**Board of Adjustments
Meeting Agenda
March 12, 2025
Bentonville City Hall
Meeting Time: 4:00 PM**

Walmart Campus Signage - Hotel Ventures Bentonville LLC

Project Number	VAR25-0006
Applicant / Current Owner	John Trahan / Hotel Ventures Bentonville LLC
Site Area	+/- 6.76 Acres
Current Zoning	Planned Unit Development (PUD)
Variance Request	Sec 801.15 Signs Allowed With A Sign Permit, a) Height and Area Regulations
Related projects

VAR25-0006
Campus Signage Variance
1301 SE 8TH ST

East Entry Features

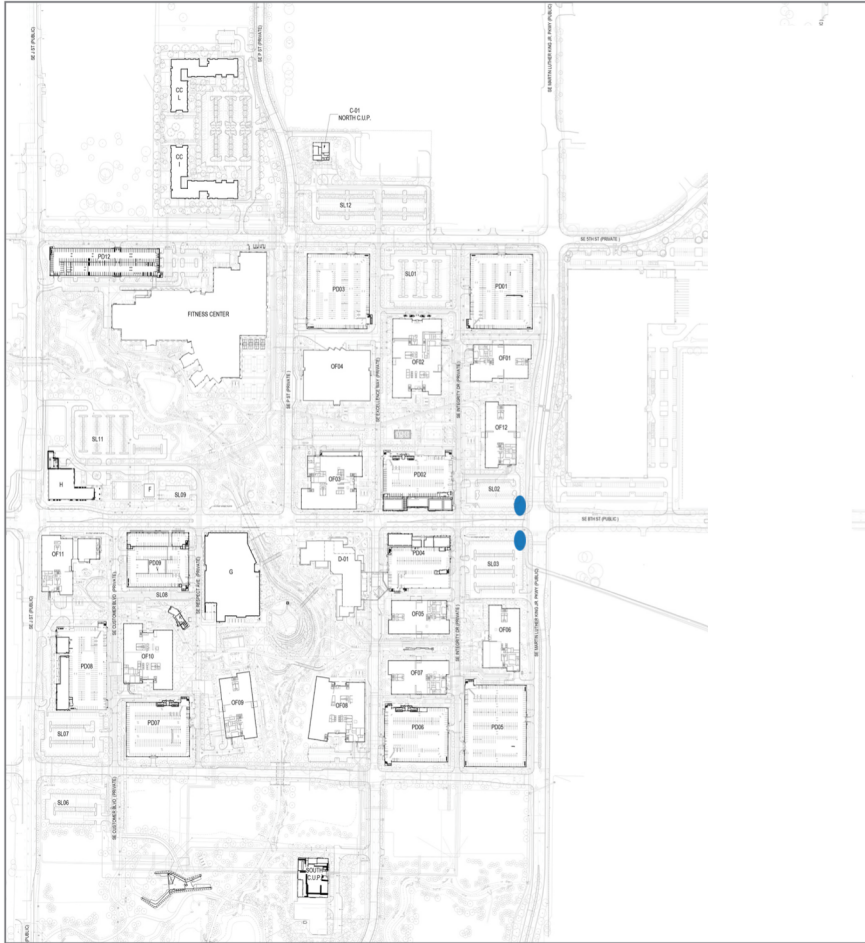
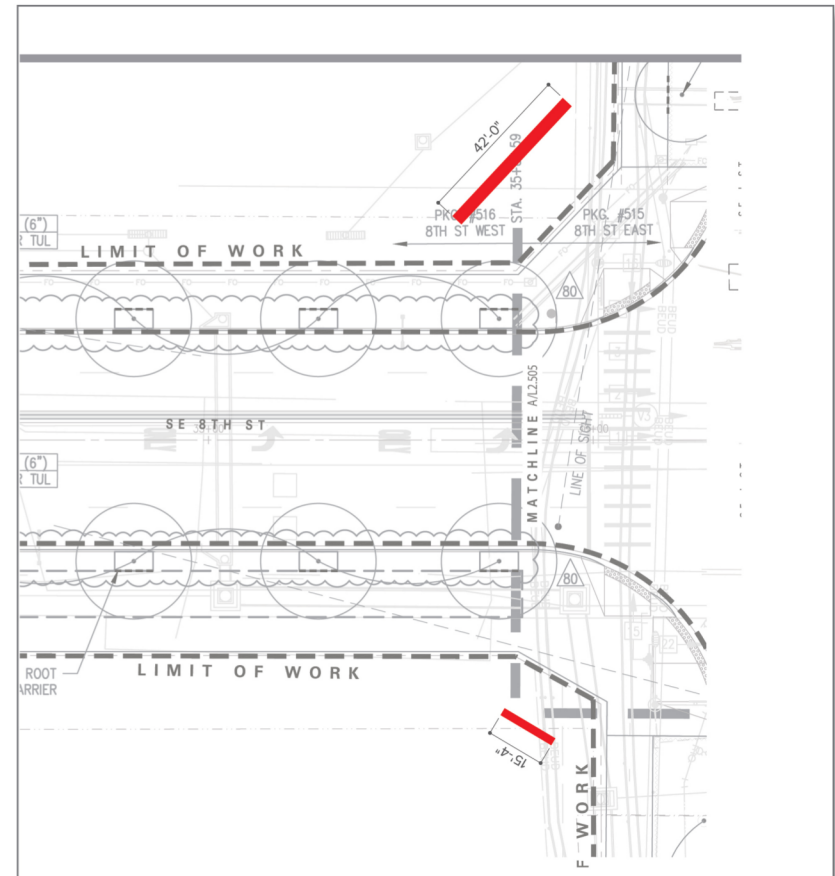
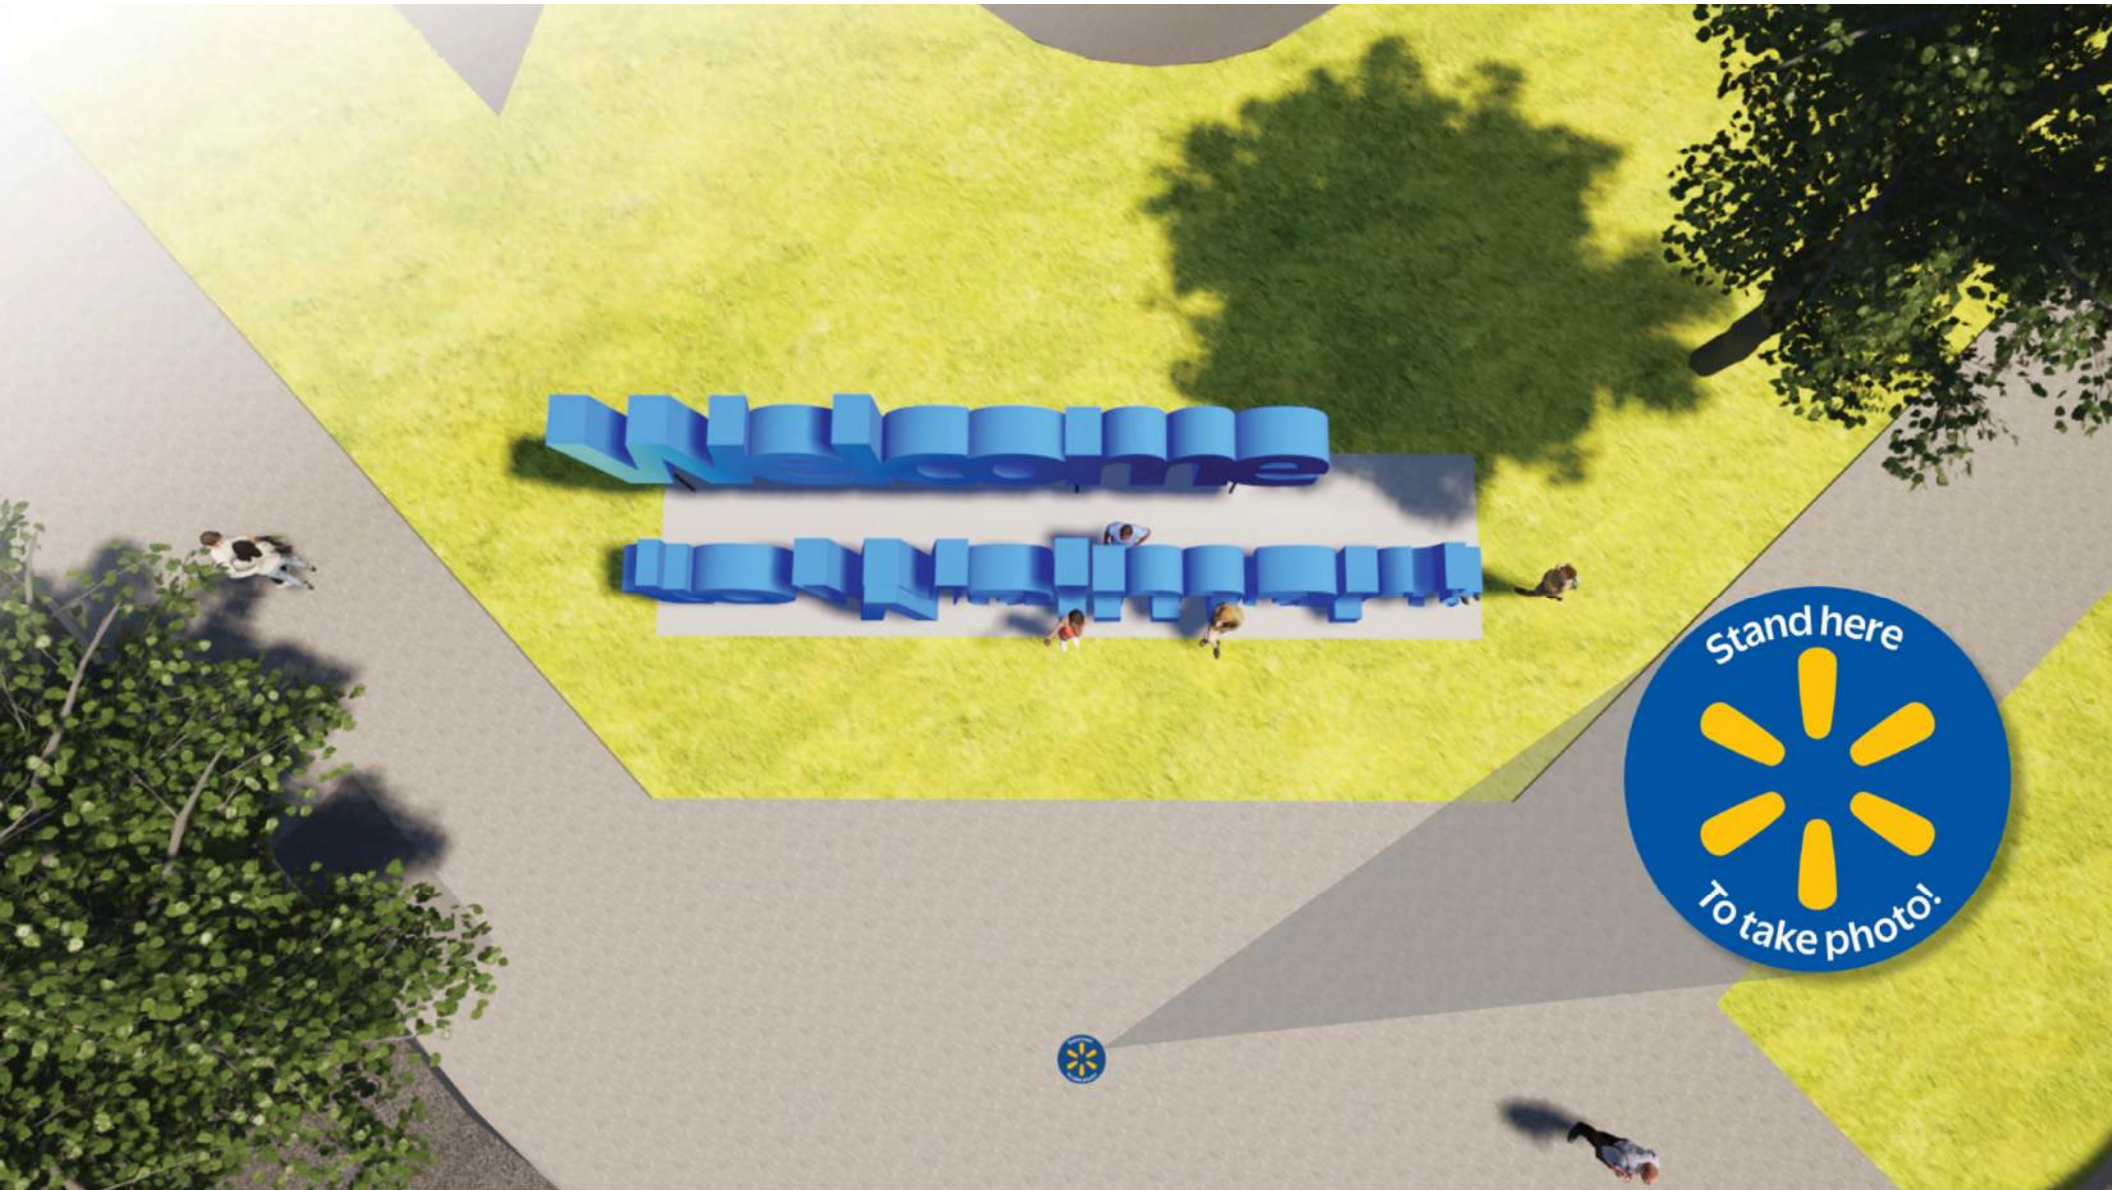
The “Welcome to Walmart” sign, roughly **12 ft height** and 42 ft wide (**504 sq. ft** approximate area per sign face) and spaced so that people can walk between some of the words, and the sign will be illuminated at night. This sign is intended to be a photo opportunity, and a sticker would be placed on the ground in front with the spark logo indication where people can stand to take pictures with the sign. It is specifically intended for the enjoyment of the community.

The “Walmart Badge” sign, roughly **10 ft height** and 14.5 ft wide (**145 sq. ft** approximate area per sign face) is divided into three sections with a digital component where the center part of the badge is a screen that will scroll associate’s name and can be changed. The digital scroll message will be displayed for a minimum dwell time of eight (8) seconds and maximum transition time between message shall not exceed one (1) second per Sec 801.17 Digital Billboards (e). This sign will also be illuminated at night.

Feature B

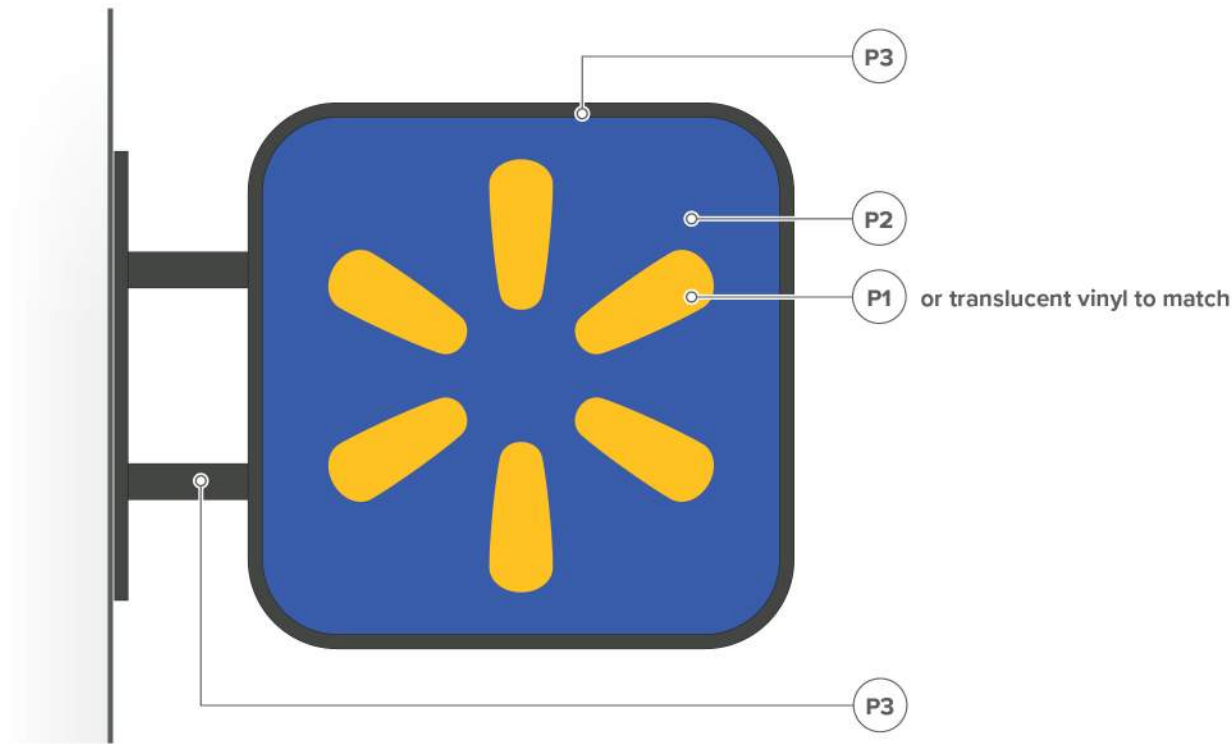
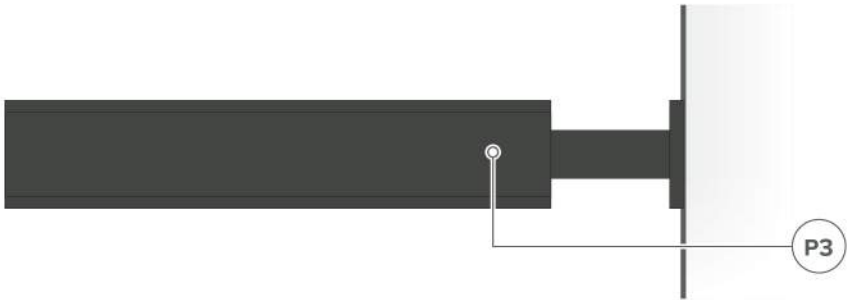
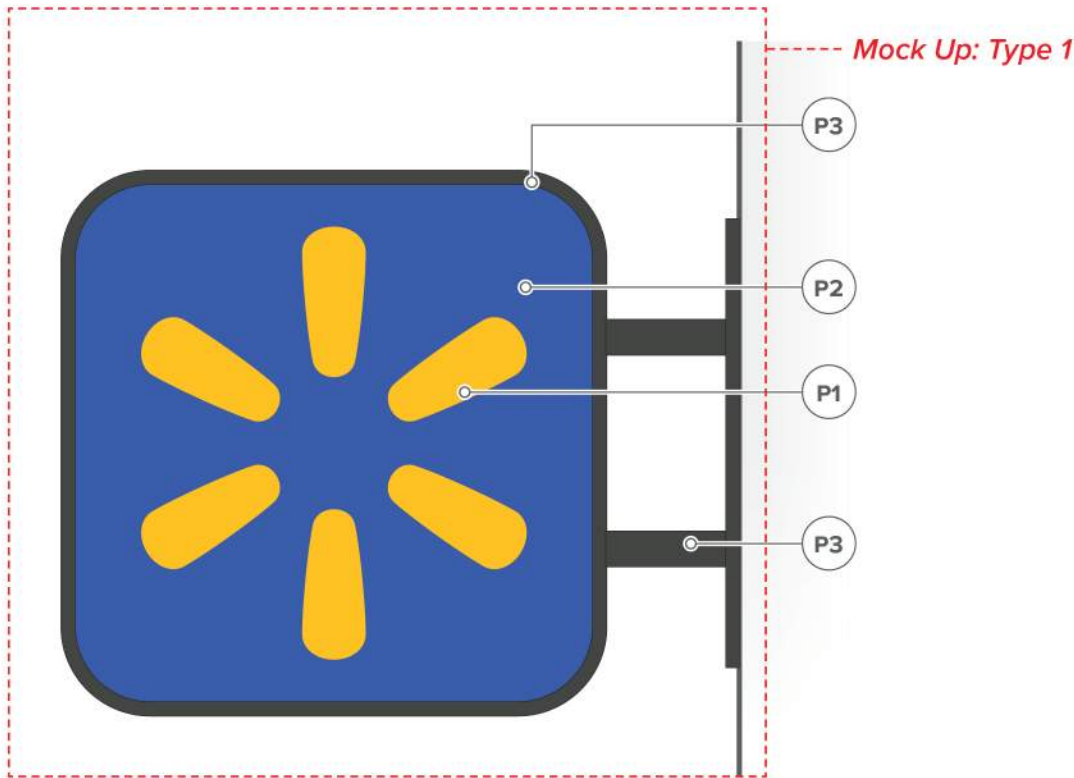
The “OF11 Blade” projecting wall mounted sign, roughly **7 ft 7 in height** and 7 ft 7 in wide (**60 sq. ft** approximate area per sign face) projects 9 ft 5 in into SE 8th St right-of-way (currently no air space agreement), and the spark sign will be illuminated at night. This sign is mounted 38 ft above finish floor elevation free of head clearance from SE 8th St.
